Subject: Request for Advice on Modification 7 – Infrastructure consolidation and remediation (SSD-5544-Mod-7) (Sutherland Shire)

CPHR comments on Modification 7 Infrastructure consolidation and remediation (SSD- 5544- Mod-7) (Sutherland Shire)

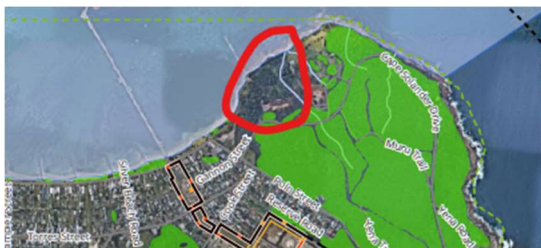
4.	<i>BDAR - percentage of native vegetation cover</i>	Figure 3-1 of the BDAR ('native vegetation extent') may not have mapped all native vegetation in the north-eastern area of the Kurnell Peninsula as shown in red in the screen-capture below. 
----	---	---

Recommended action: The ecological consultant reviews the native vegetation mapping extent presented in Figure 3-1 of the BDAR and updates the mapping and calculations if required.
	<i>Extent and Timing</i>	Prior to Response to Submissions.
